Addendum #2

Issued March 7, 2025

Project: Hamilton-Wentworth District School Board
REFERENCE NO. 2025-137-P02085
Franklin Road Music Corridors and Washroom Renovation

Project: HWDSB-P02085 – Franklin Road ES Renovation

SK-01 AD-01

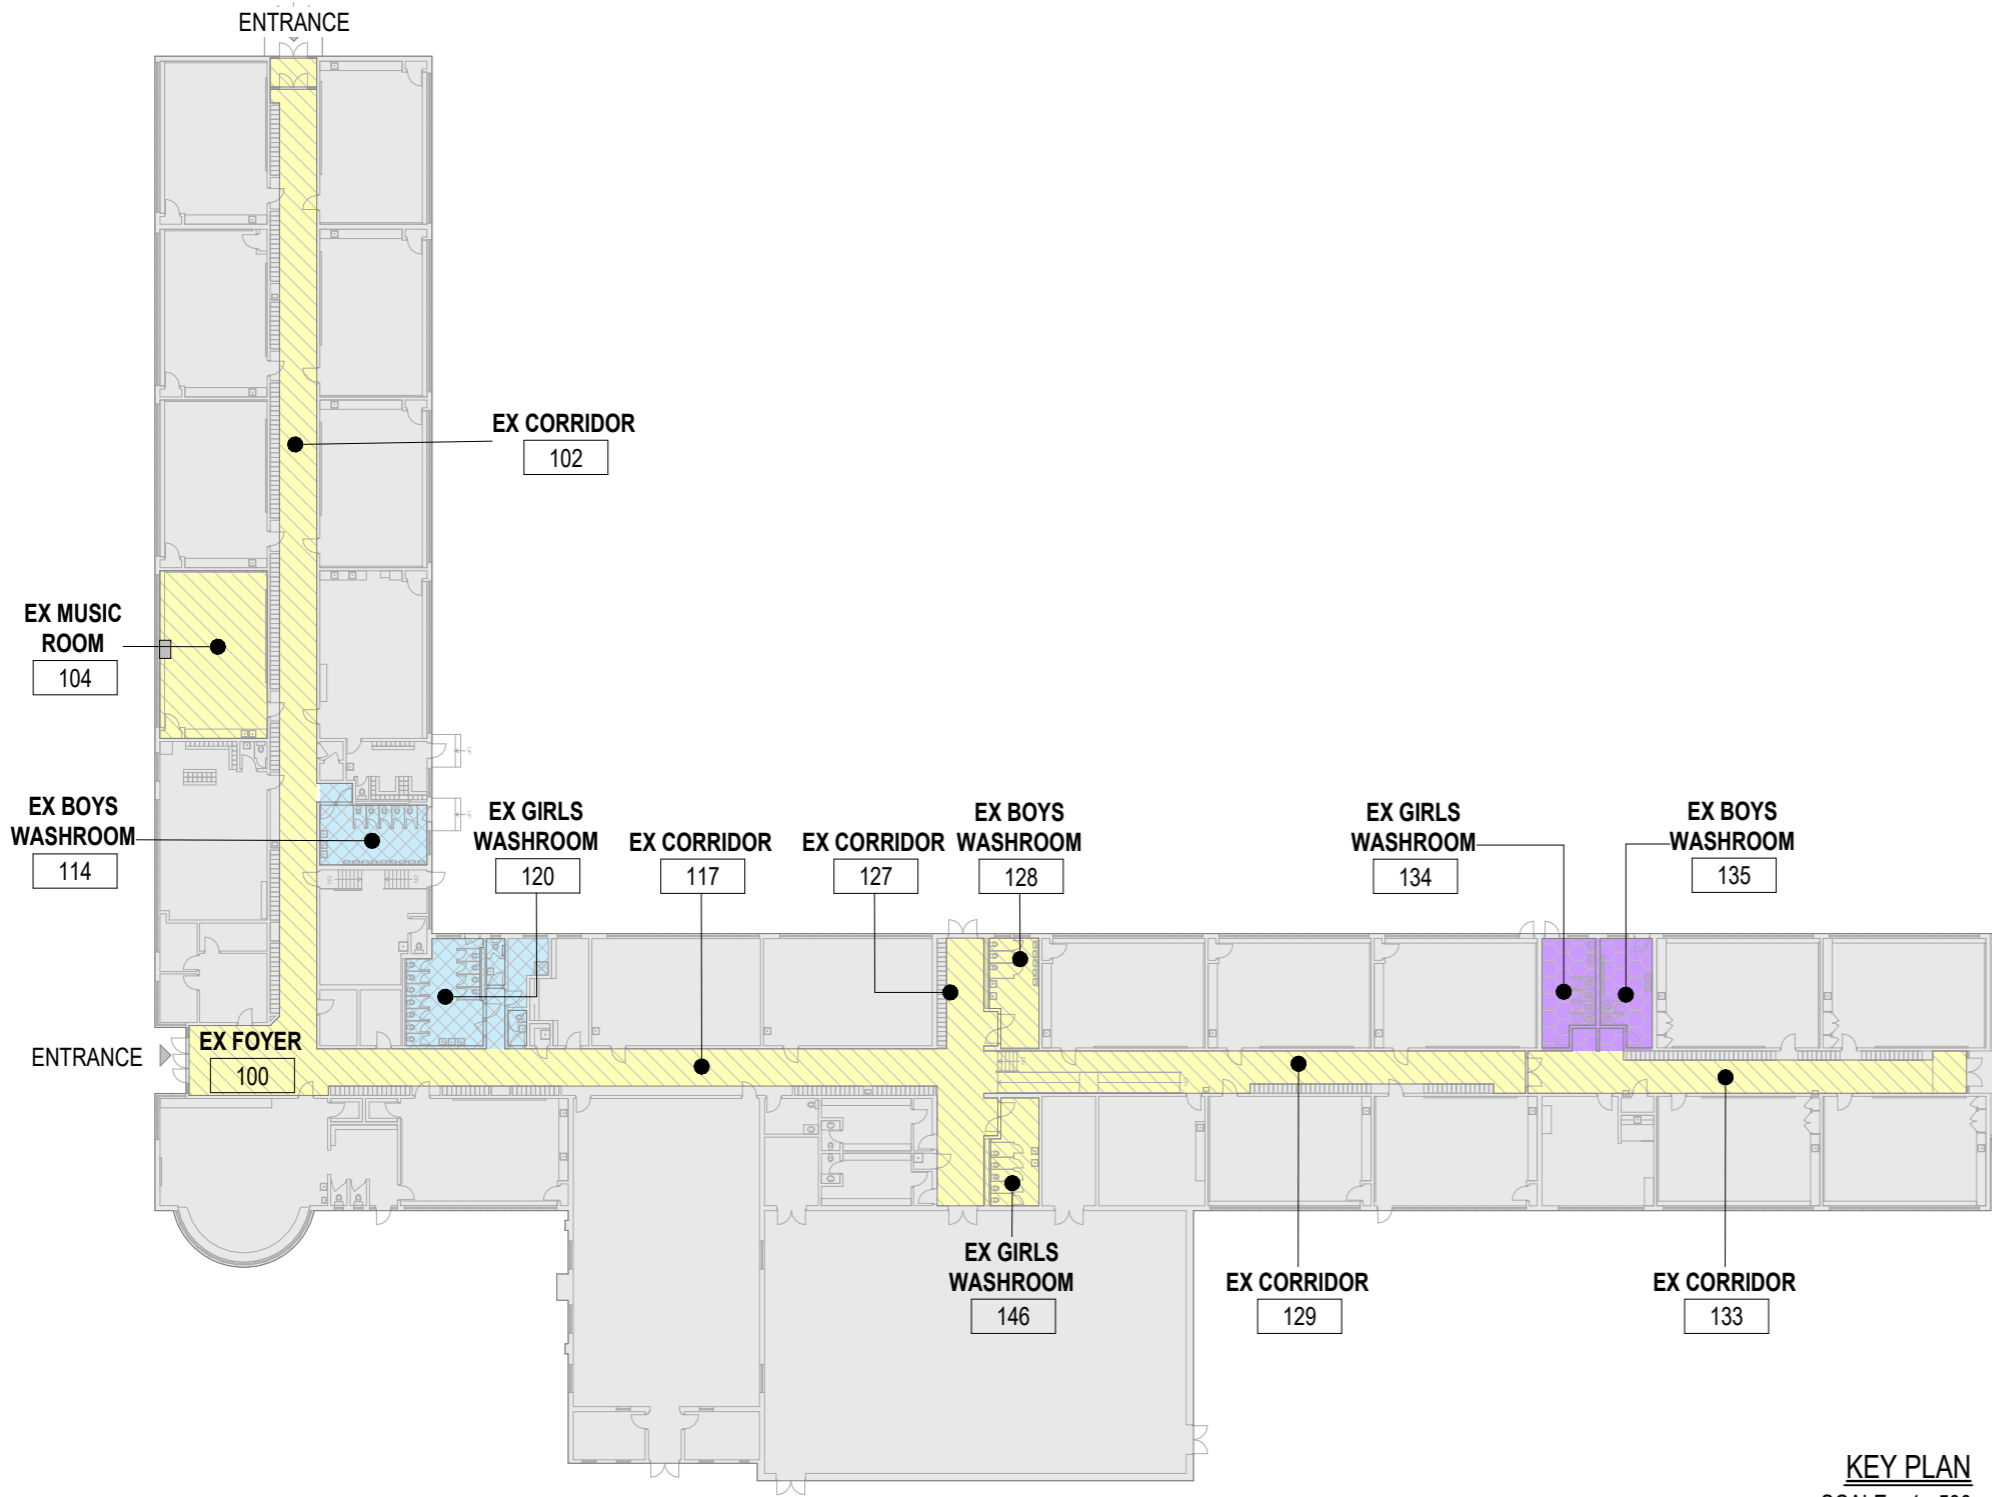
- 3.1. Drawing A0.01, Furring Wall Schedule – F2:
Replace 38 mm furring channels with 64 mm steel studs
- 3.2. Drawing A2.00 – Room Finish Schedule
ADD Note: Ceramic tiles wall finish to be 1,800 mm high.
- 3.3. Drawings A2.01, A2.03, A2.04, A2.05 – Floor Plans
Refer to the **attached** Sketch SK AD-01 for the General Tile Pattern Layout.
Applicable to all washrooms with tile floor finish.
- 3.4. Drawings A2.01 – DOOR SCHEDULE
Door # D123: Add: Modify existing door as required for new floor tile finish

Drawing 001:
 MECHANICAL SYSTEMS - NEW OVERALL PLAN.

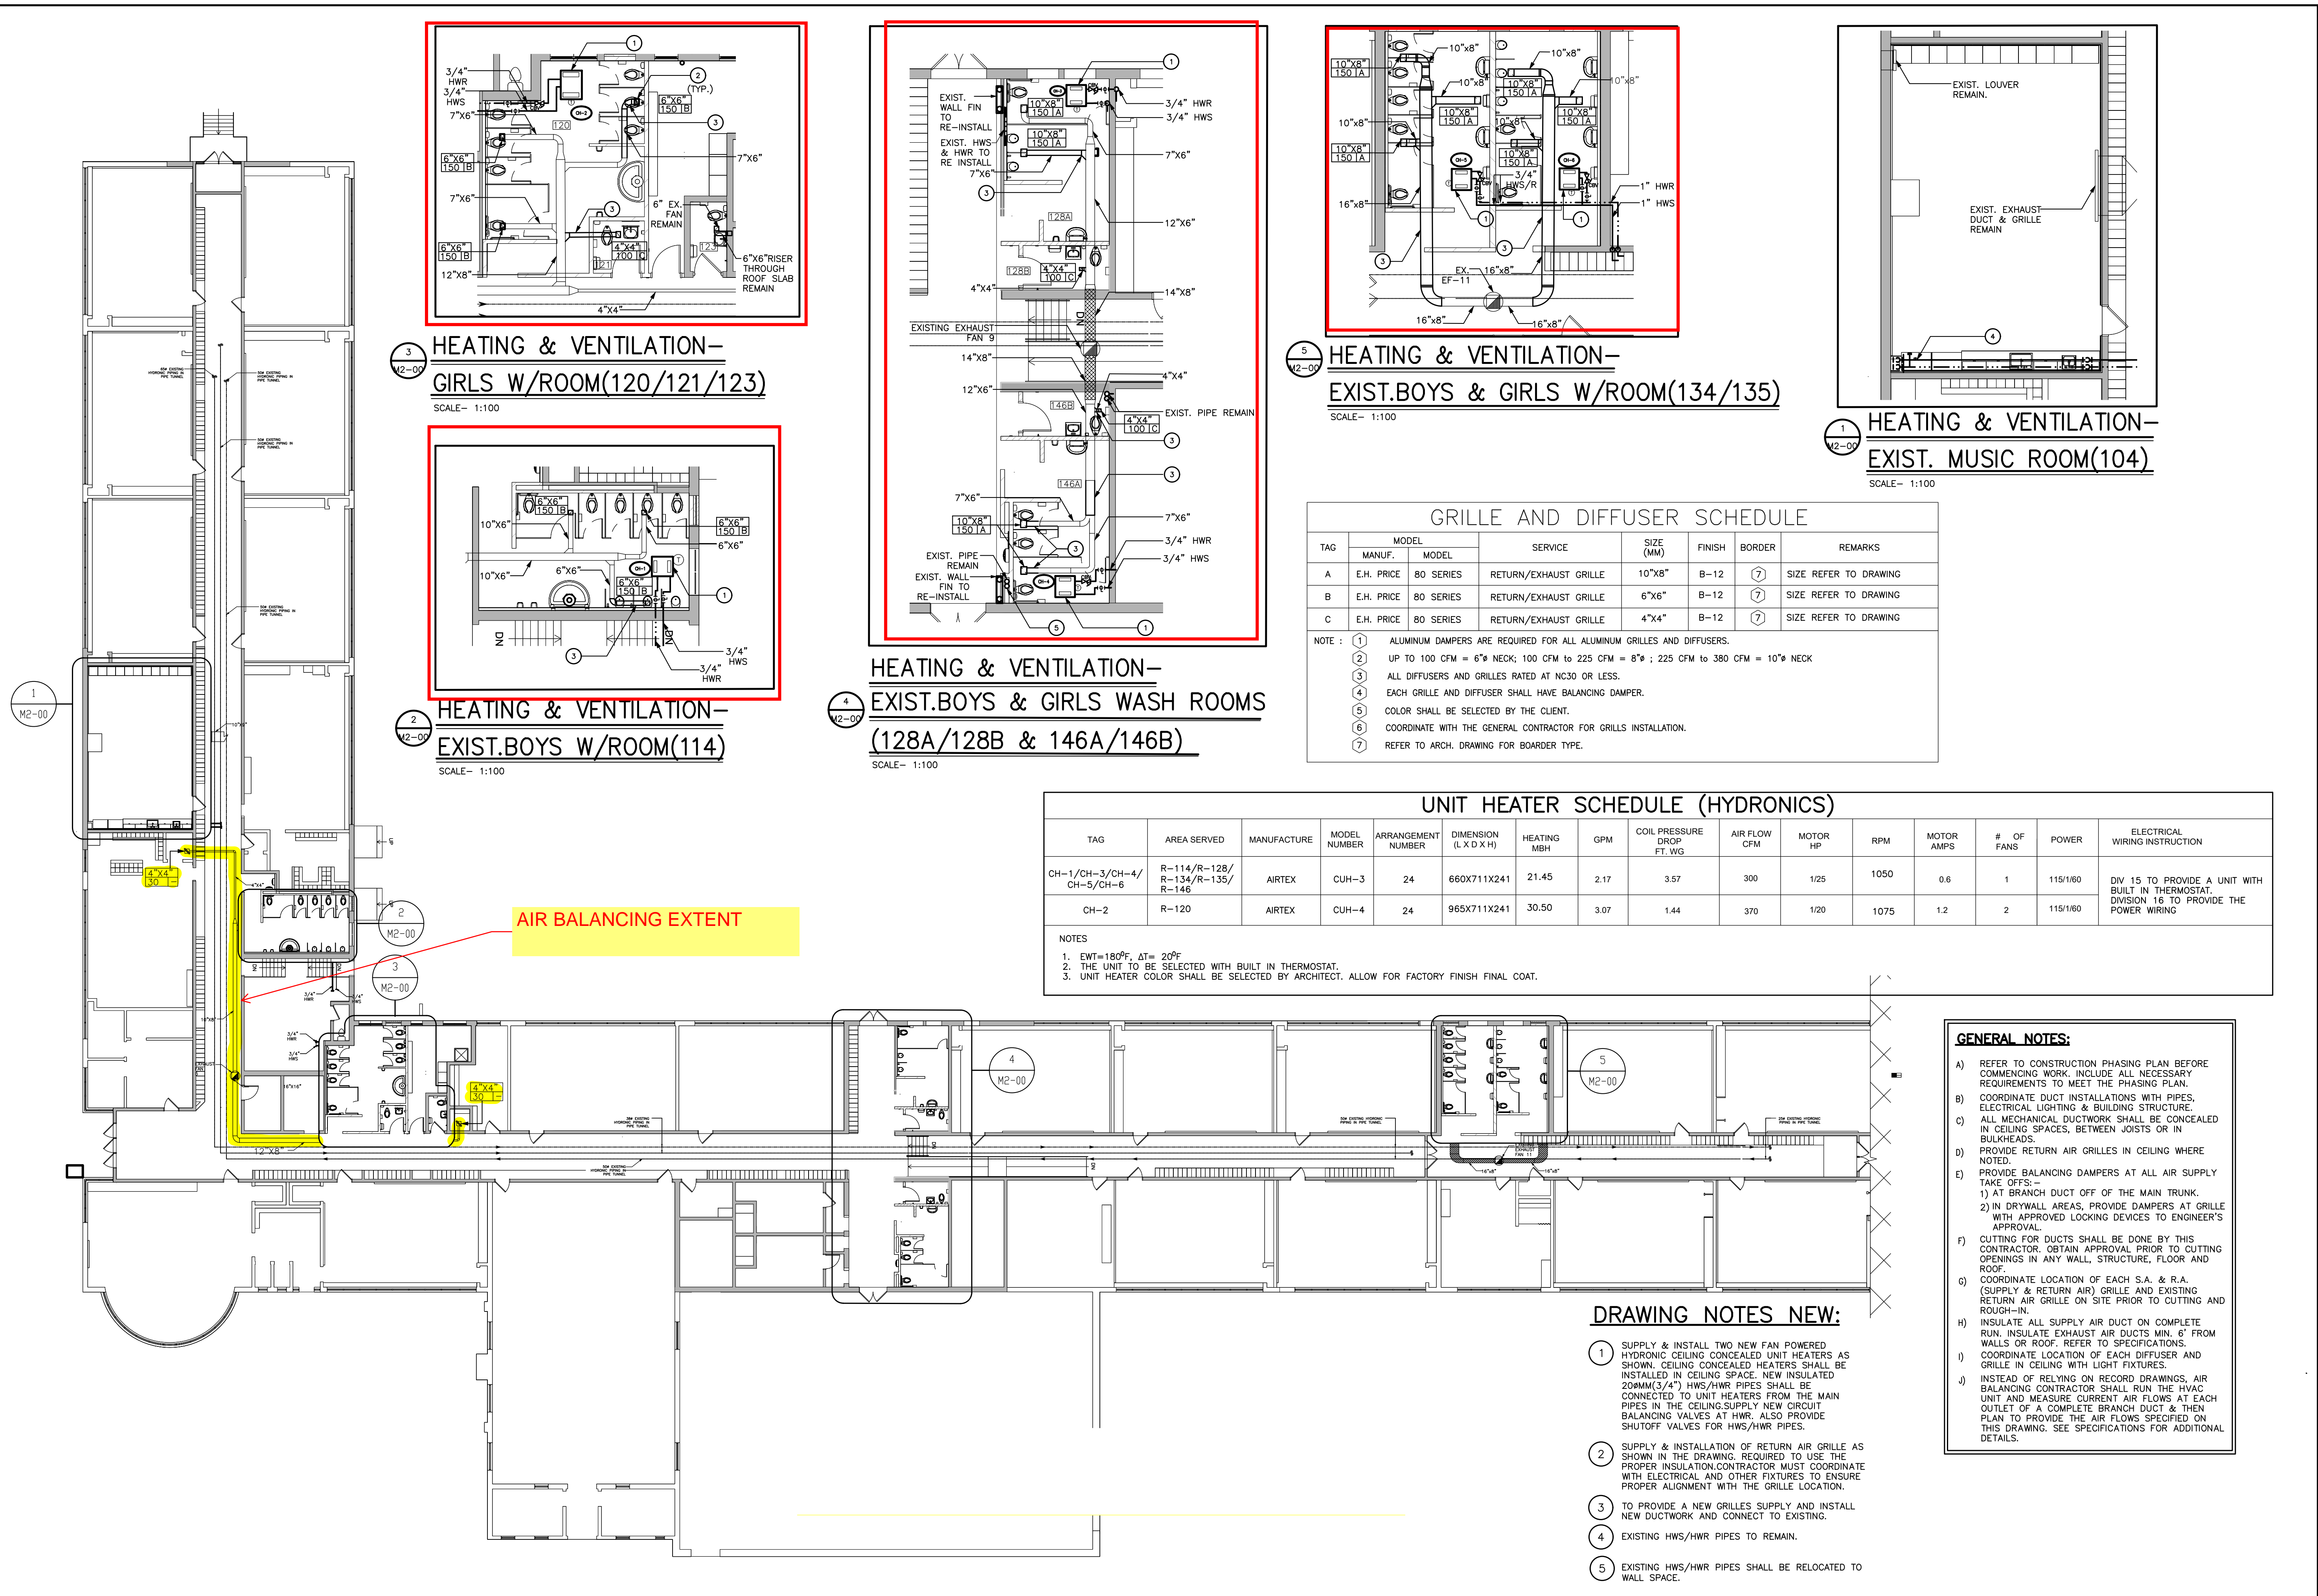
- SUPPLY & INSTALL TWO NEW FAN POWERED HYDRONIC CEILING CONCEALED UNIT HEATERS AS SHOWN. CEILING CONCEALED HEATERS SHALL BE INSTALLED IN CEILING SPACE. NEW INSULATED 20MM(3/4") HWS/HWR PIPES SHALL BE CONNECTED TO UNIT HEATERS FROM THE MAIN PIPES IN THE CEILING. SUPPLY NEW CIRCUIT BALANCING VALVES AT HWR. ALSO PROVIDE SHUTOFF VALVES FOR HWS/HWR PIPES.
- SUPPLY & INSTALLATION OF RETURN AIR GRILLE AS SHOWN IN THE DRAWING. REQUIRED TO USE THE PROPER INSULATION. CONTRACTOR MUST COORDINATE WITH ELECTRICAL AND OTHER FIXTURES TO ENSURE PROPER ALIGNMENT WITH THE GRILLE LOCATION.
- TO PROVIDE A NEW GRILLES SUPPLY AND INSTALL NEW DUCTWORK AND CONNECT TO EXISTING.
- EXISTING HWS/HWR PIPES TO REMAIN.
- EXISTING HWS/HWR PIPES SHALL BE RELOCATED TO WALL SPACE.
